06-17-24 CAVA YUKON, OK (10TH ST)

Project Issue Information

IMG_1234.jpeg

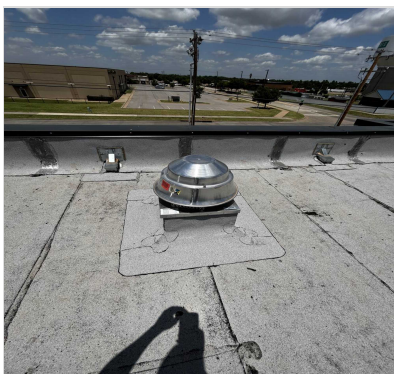
Issue Name : EF2 - AIRFLOW
Description : FAN IS ON HIGH AIRFLOW, NO FAN SPEED CONTROLLER INSTALLED. RECOMMEND INSTALLED SPEED CONTROLLER TO BRING FAN INTO DESIGN.
Created By : National TAB **Assigned To :** National TAB - Will Turnbough
Status : Open
Priority : Urgent **Asset Tag :**
Originated Date : 06/19/2024 - Kristopher Passley - National TAB
